Docket Number:	17-AAER-06
Project Title:	Commercial and Industrial Fans & Blowers
TN #:	224802
Document Title:	Daikin Applied Comments Corrected Fan Cost Estimates for Embedded Fans
Description:	N/A
Filer:	System
Organization:	Daikin Applied/Skip Ernst
Submitter Role:	Public
Submission Date:	9/27/2018 11:08:18 AM
Docketed Date:	9/27/2018

Corrected fan cost estimates for embedded fans

Daikin Applied Comments: Commercial and Industrial Fans and Blowers (CIFB)

Subject: Docket # 17 AAER-06

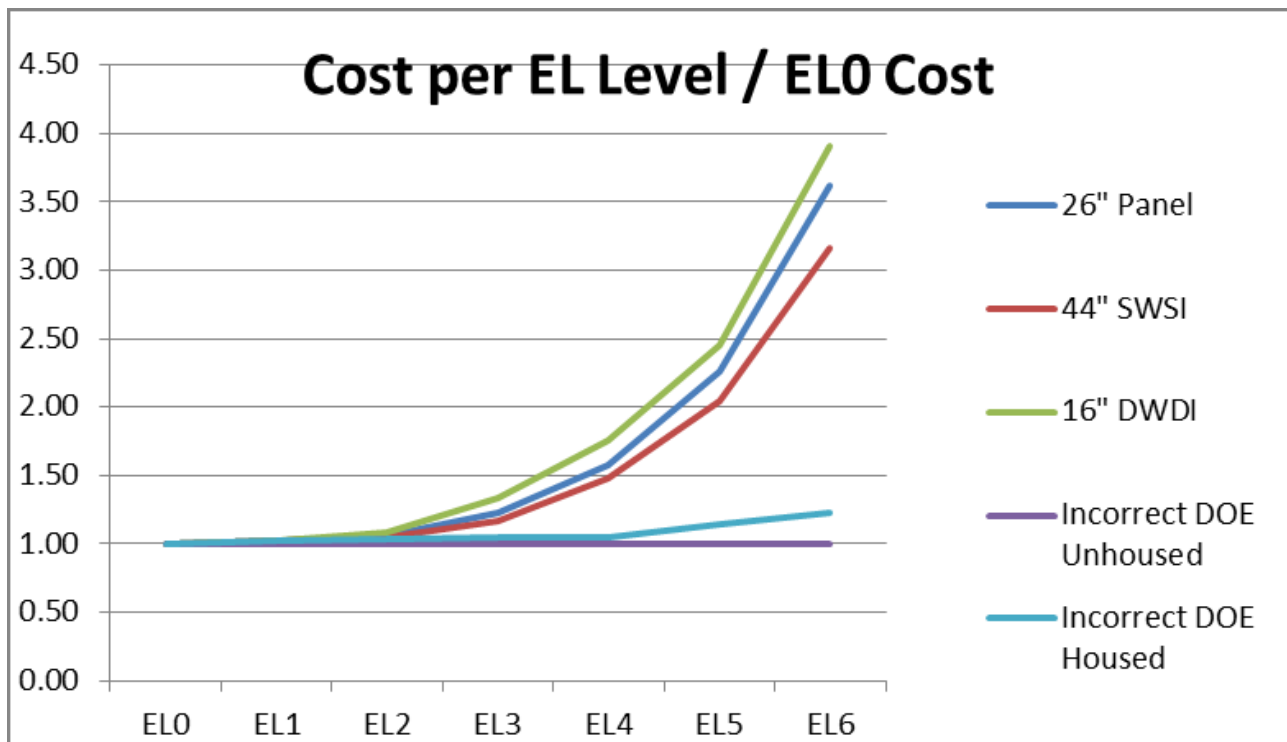
- DOE's 3rd NODA understates the MPC cost difference between EL levels for panel, housed centrifugal, and unhoused centrifugal fans. Corrected cost ratios per EL level for panel, housed and unhoused centrifugal fans are shown in the chart below. See confidential page 4 for specific examples.
- The Tear Down Sheet in the Engineering Analysis indicates only one actual, 20" diameter and two virtual, 20" diameter tear downs were performed. This is insufficient because of the many fan variations. Their conclusion of almost no cost difference between EL levels is very poor.
- DOE MPC cost estimates do not include the cost of larger cabinets that will often be required to enclose more efficient fans. Furthermore; associated curb adapter and new support structures for larger replacement units are also not accounted for in the installed cost.
